**EVALUATION OF SEISMIC HAZARDS AT PROPOSED VANCOUVER
ENERGY OIL EXPORT TERMINAL, PORT OF VANCOUVER,
WASHINGTON**

Report
Evaluation of Seismic Hazards at
Proposed Vancouver Energy Oil Export
Terminal, Port of Vancouver,
Washington.
URS Job No.: 33765022
AECOM Job No.: 60392591

AECOM submits Revision 2 of the subject report. Revision 1 was based on Cardno's comments of our June 8, 2015, draft, and Revision 2 was minor editing that AECOM made. Please contact us if you have additional comments.

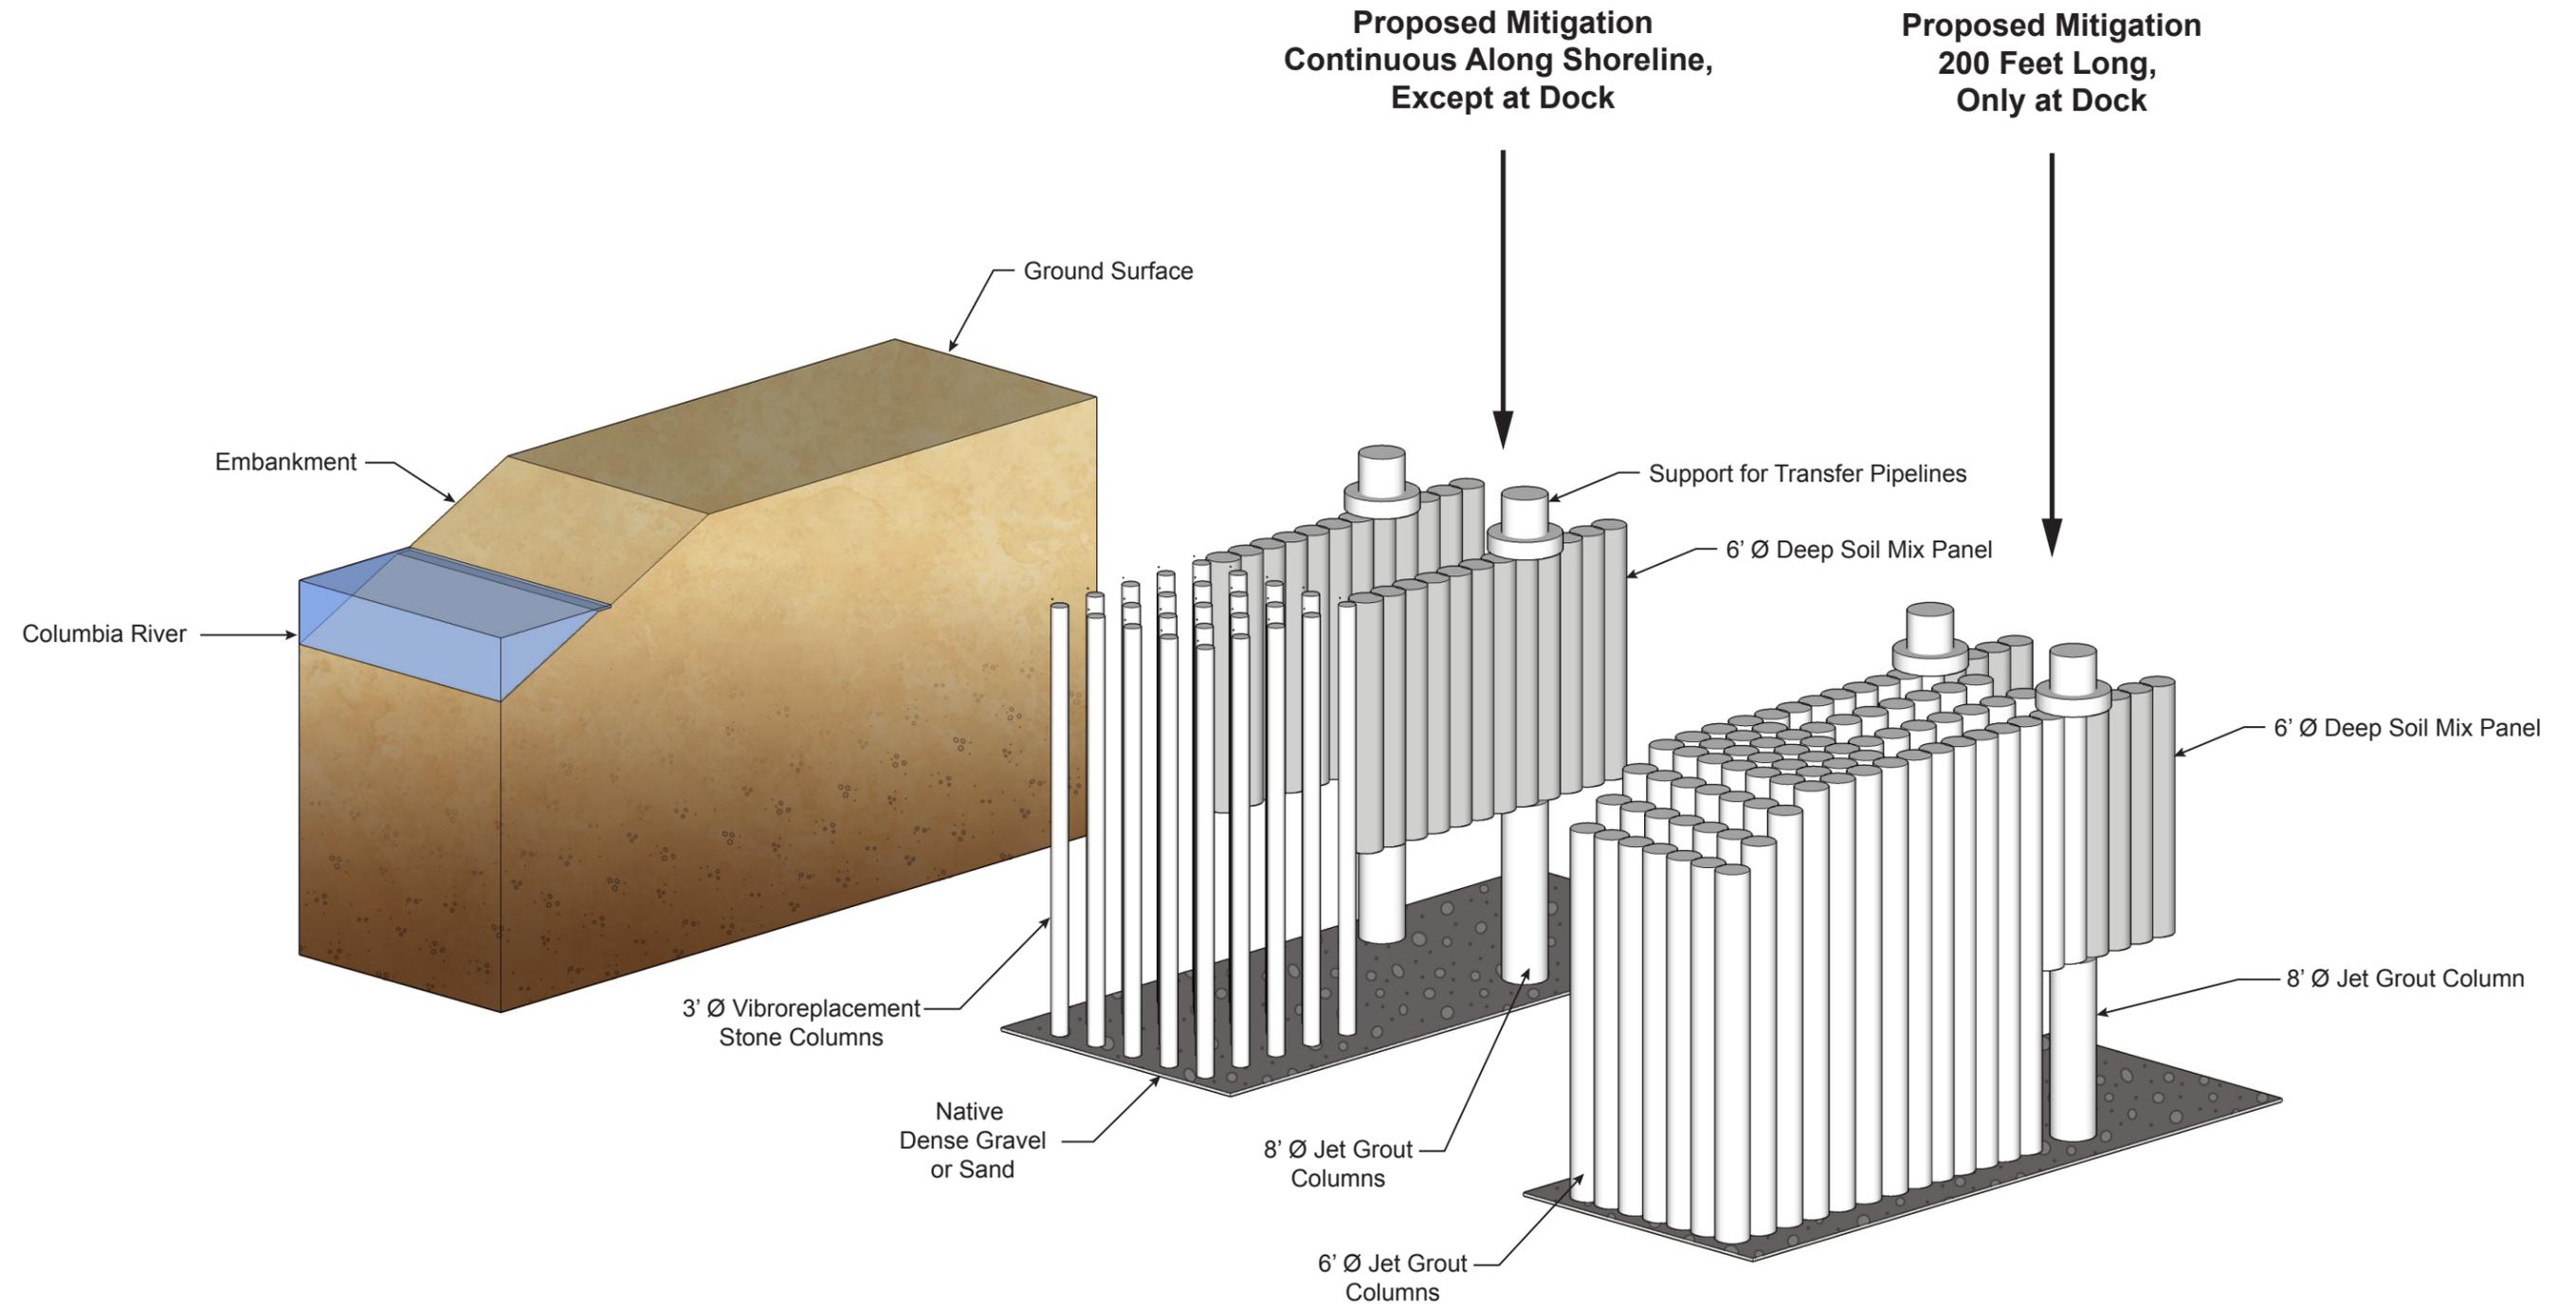
The ground-improvement design in the HBI documents (illustrated schematically in Figure 5-6 at the end of Section 5) appears to allow some of the vibroreplacement stone columns to terminate at depths that may not fully penetrate the liquefiable soil zone unless additional confirmatory and mitigation efforts are employed during the stone-column installation process.

A second item of concern is that the combination of deep soil mix panels supported on top of jet grout columns is not a concept with a well-established performance record. Therefore, AECOM recommends that the anticipated performance be checked more thoroughly using advanced numerical methods such as FLAC (Fast Lagrangian Analysis of Continua) or PLAXIS. This type of computer analysis can provide more reasonable estimates of ground deformation that better assess the potential risk to the Transfer Pipeline system.

AECOM recommends that the currently planned stone column tip elevation level (Elev -53) be reconsidered in light of the apparently significant number of explorations where the top of the dense Troutdale gravel layer is Elevation -55 or deeper. Also, there is uncertainty that the lower portion of the overlying sand is sufficiently dense to prevent liquefaction at those increased depths. Alternatively, the stone column installation procedure could include a requirement that the penetration rate/resistance of the vibratory probe be set to match that where stone columns were installed at the location of explorations where dense sand was clearly identified at the stone column termination depth.
